**RE: Value Planning Study Final Report – Comox Valley Water Treatment Project**

# Value Propositions Implementation Response

# Value Planning Study

Alternative No.: IR-59A

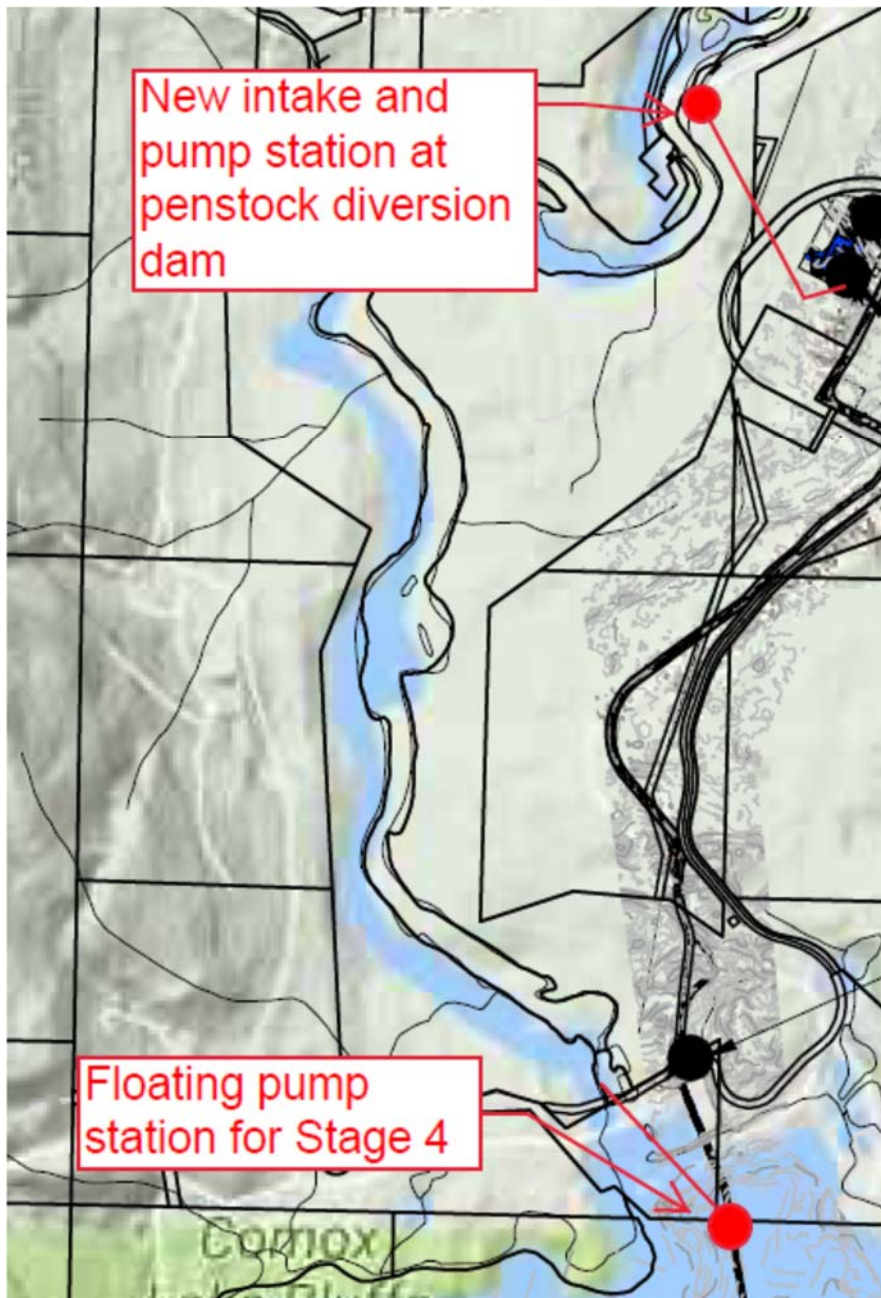
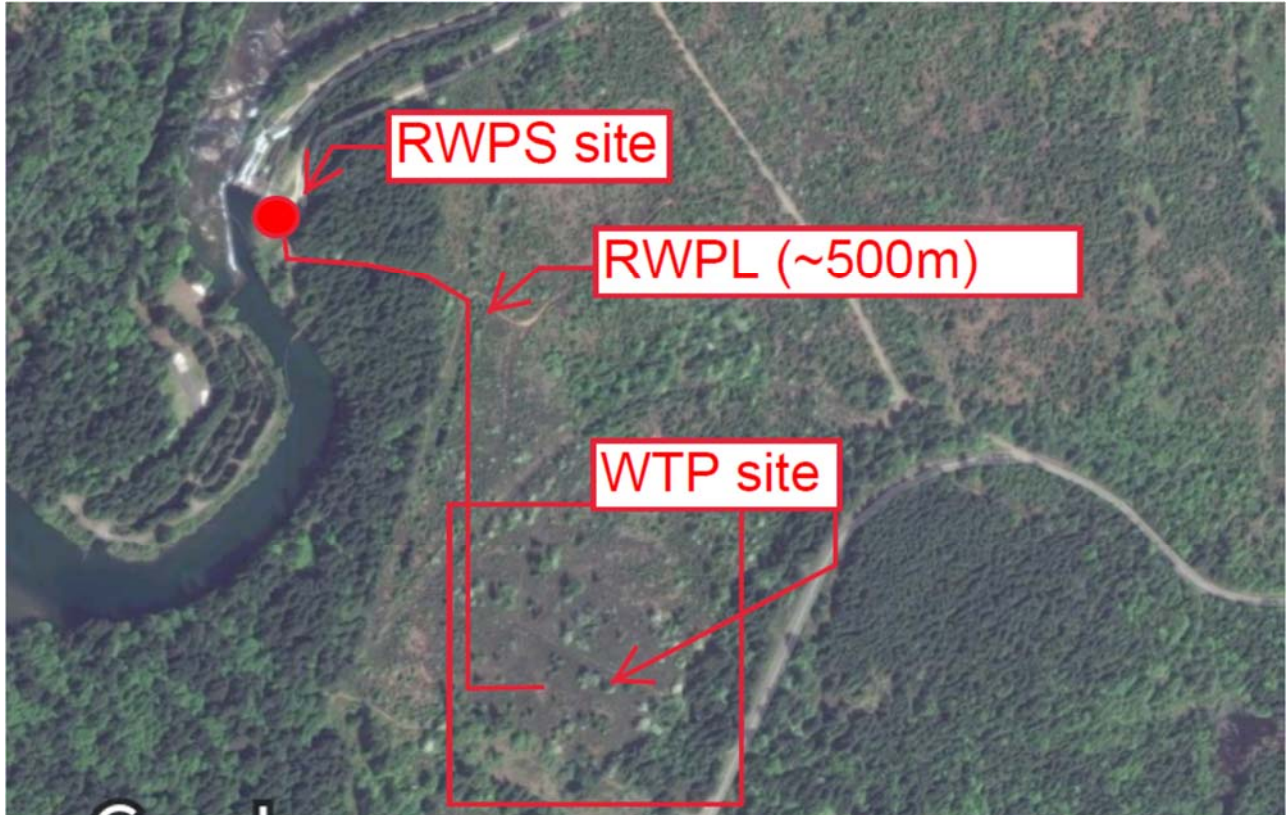
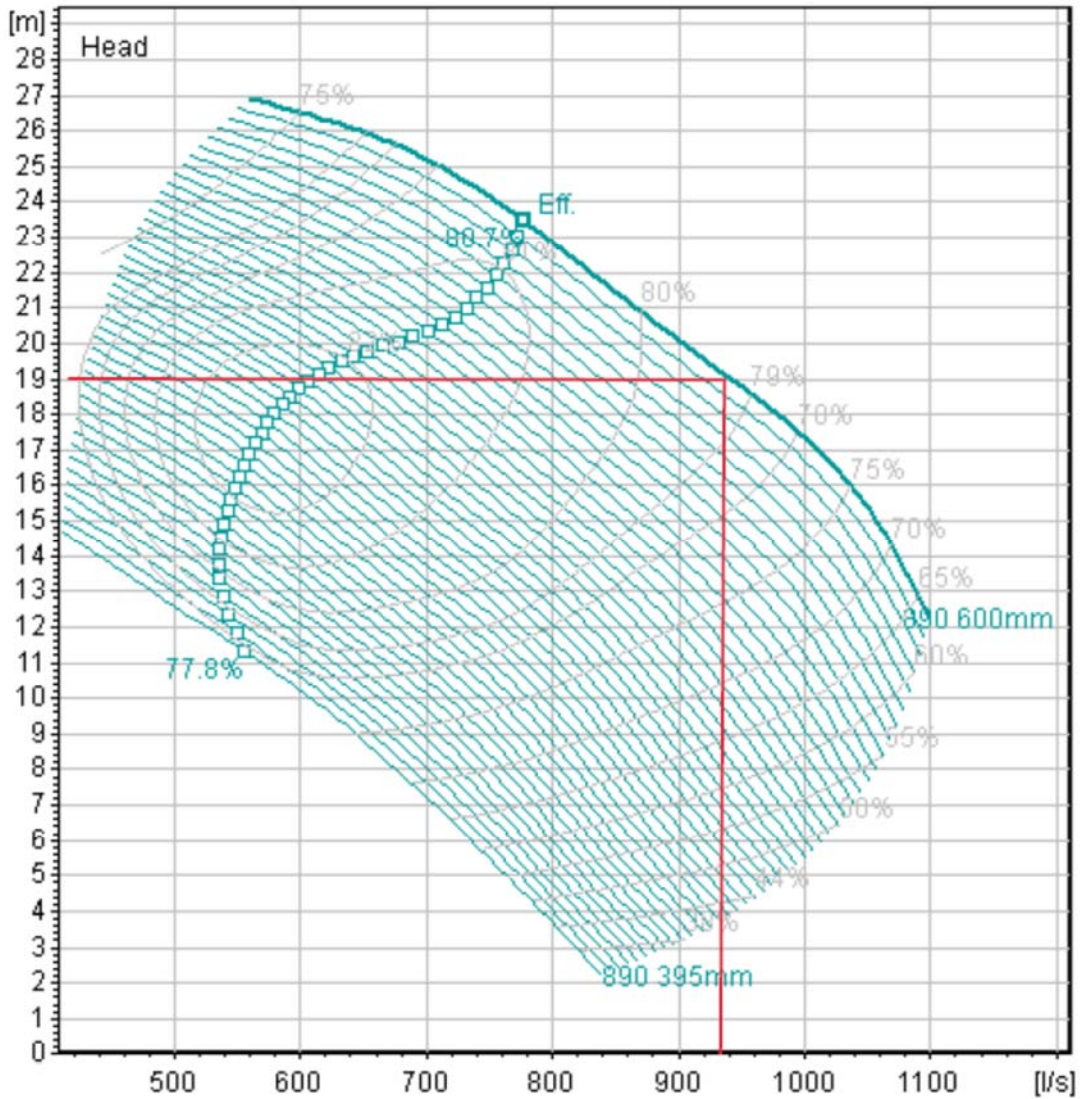
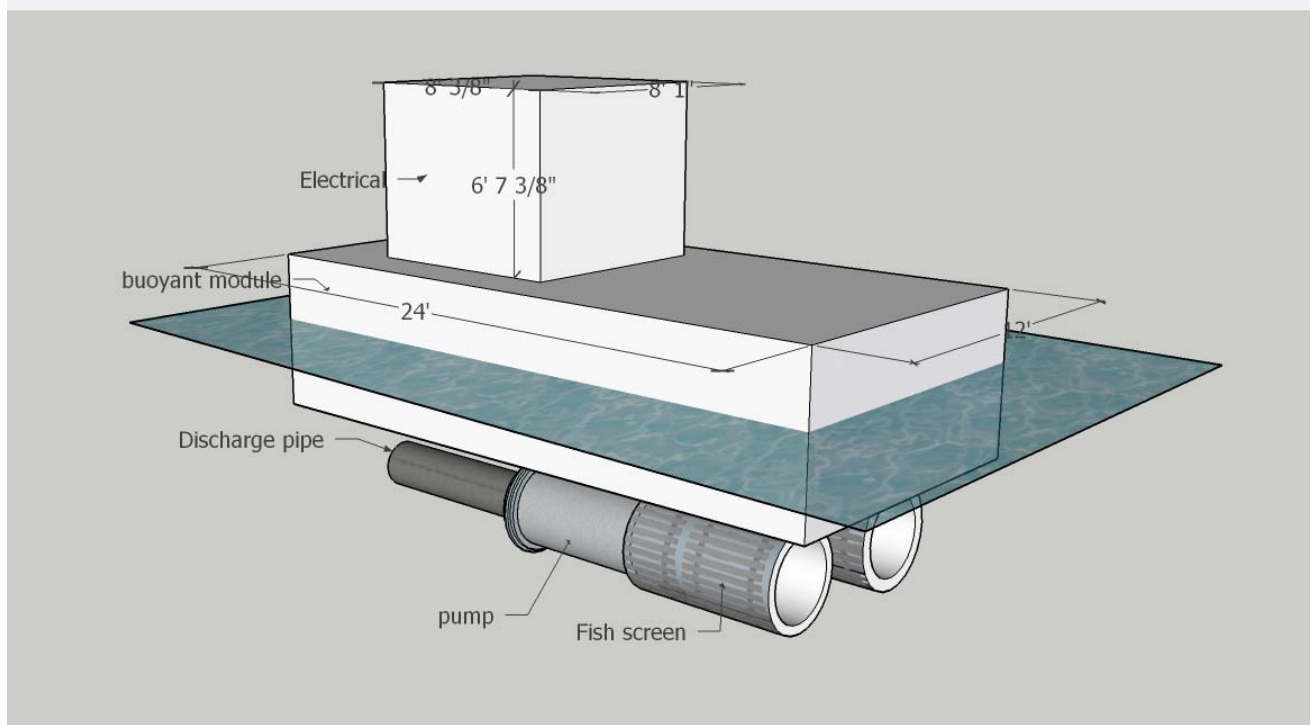
The floating pump station could be barge mounted with an underwater cable to a shore power connection point. At a TDH of about 5 m, the pump station could be comprised of two, 80 ML/d mixed flow submersible pumps each with a 75Hp motor. Total station load would be about 60 kW.

The support platform for the pumps might include a steel barge with a size of about 5x10m to include a single fish screen. The pumps would be horizontal, submersible, mixed flow pumps, with integrated and connected fish screens. The barge would be located offshore at a point where the bottom location is EL125 or less, probably about 400m from the dam. The discharge pipeline would be a 600 mm pipeline. The pipeline would be laid on the lake bottom or floated below the surface of the lake, at about a 4m depth. For purposes of this alternative a 600m pipeline on the bottom is assumed to get over the spillway.

Two alternatives proposed significantly affect the direction of the project and the way that the other alternatives were reviewed: IR-59 and PD-29. IR-59 proposed a significant change in design of the raw water supply to the treatment plant, using a river intake instead of drawing from the lake. The method to maintain water security with this option, was to deploy an additional floating pump station on Comox Lake during severe drought scenarios to pump just enough water down the Puntledge River to feed the river intake. This alternative introduced water quality, water security and contamination risks to the project. IR-59 is rejected based on this significant increase in risk to the project.

Alternative No.: IR-59B

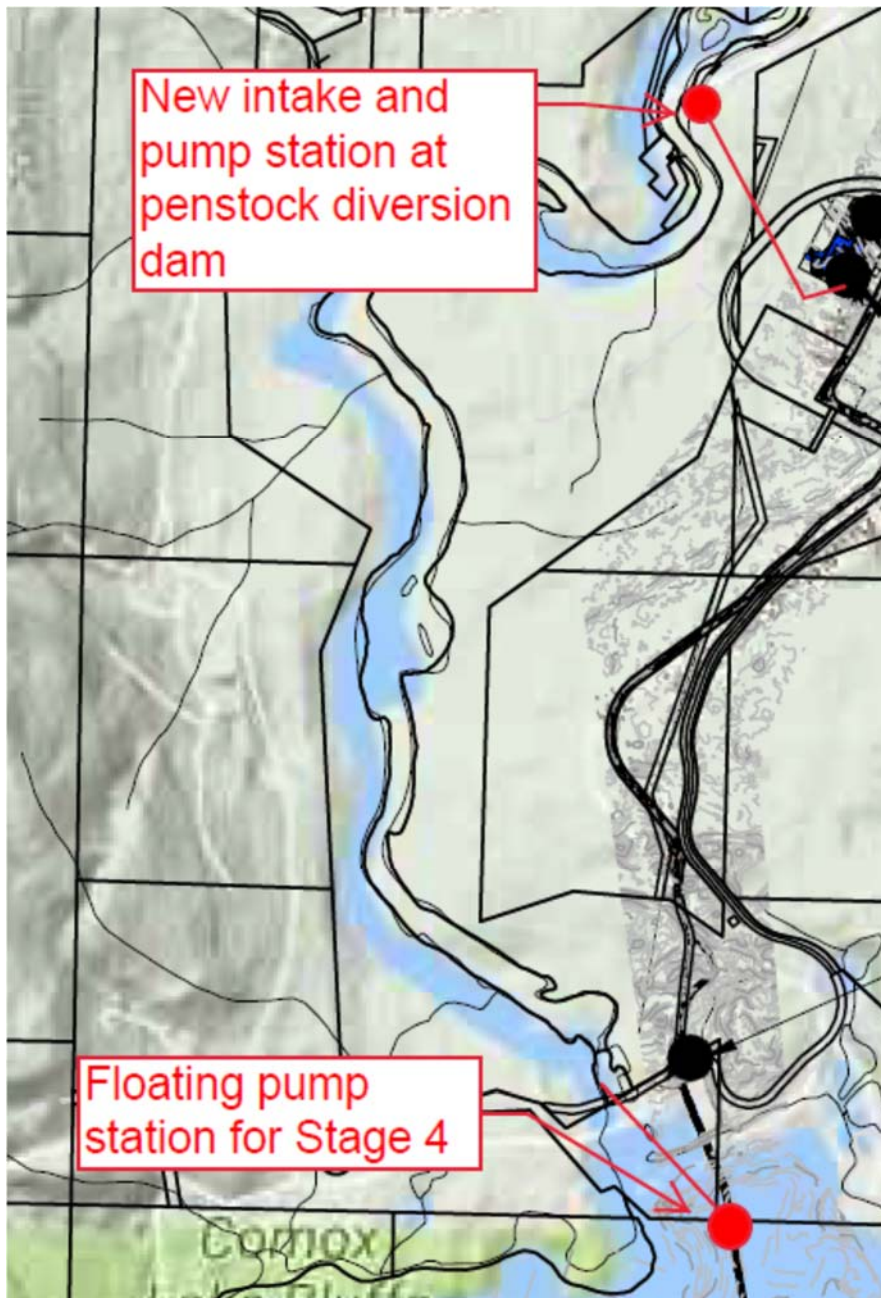
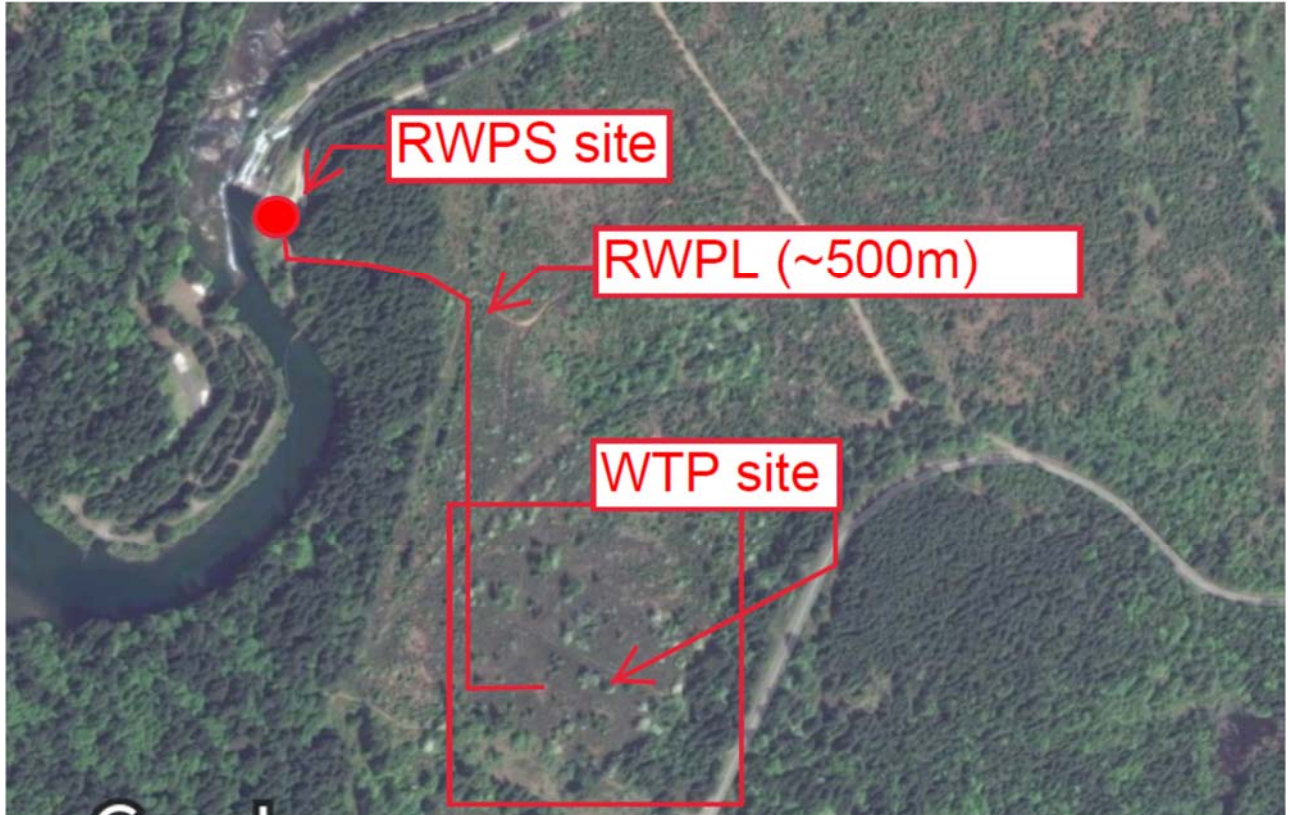
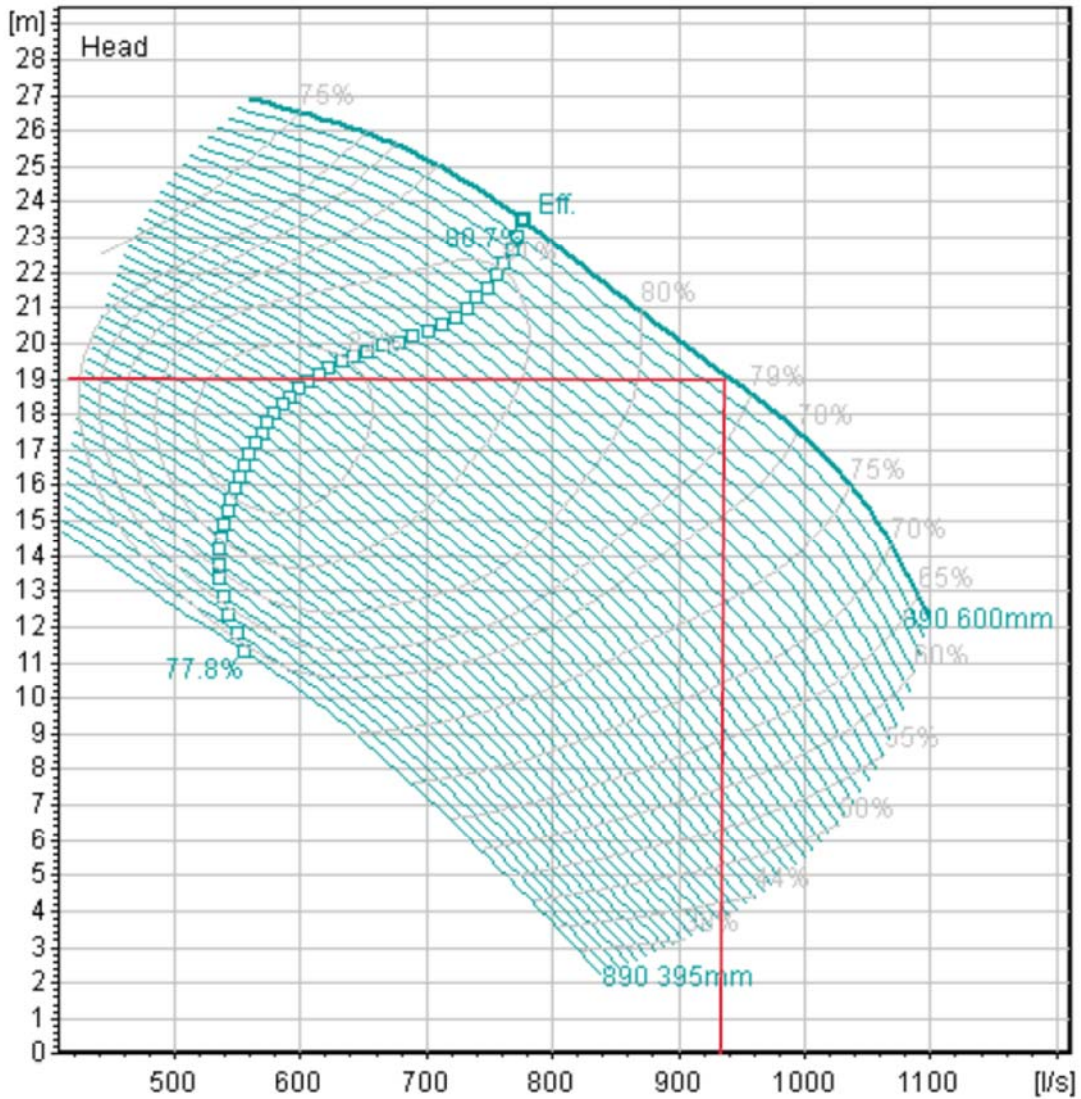
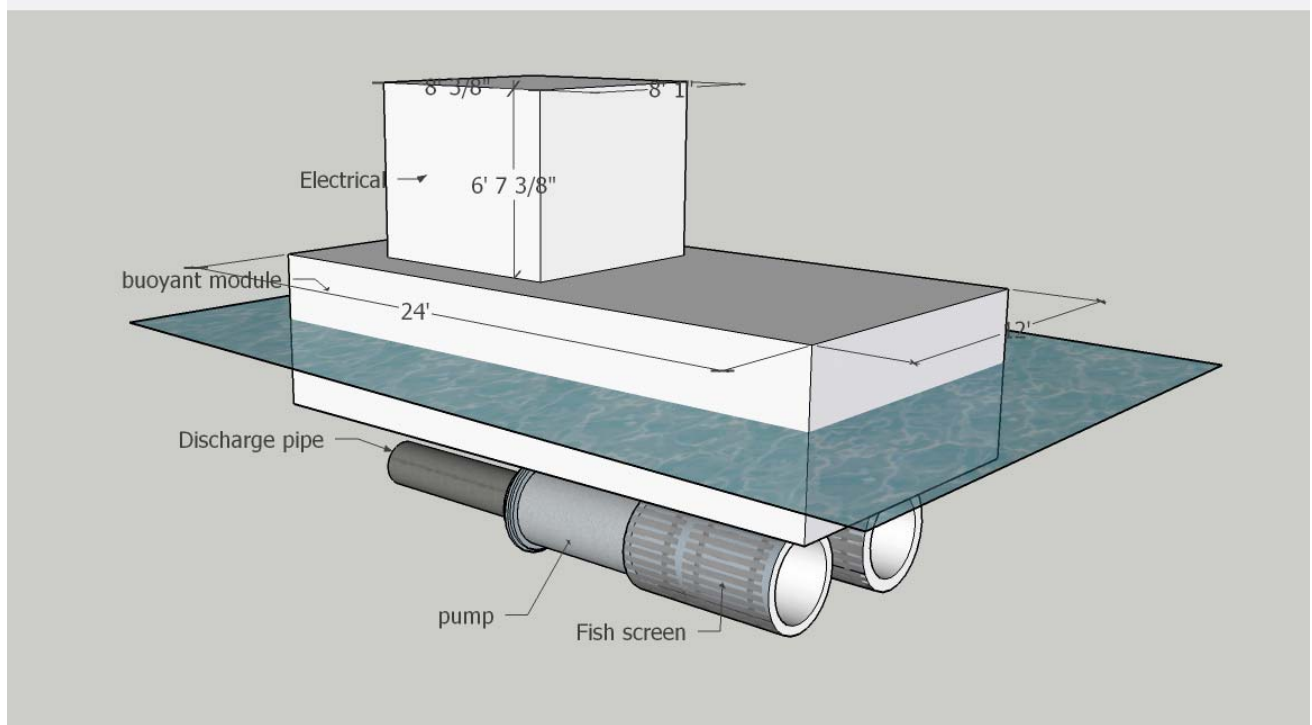
During the presentation at the end of the Value Planning workshop, a concept was discussed as part of IR-59A that if the proposed floating pump station were larger it could actually provide environmental flows (fish flows) in the river in addition to the water needed by the WTP. Following the workshop, members of the VP Team and CVRD continued to develop this concept to determine the cost implications to the project for a 140 mgd (6 m<sup>3</sup>/s) floating pump station.

The concept is the same as IR-59A except with a larger pump station capacity.
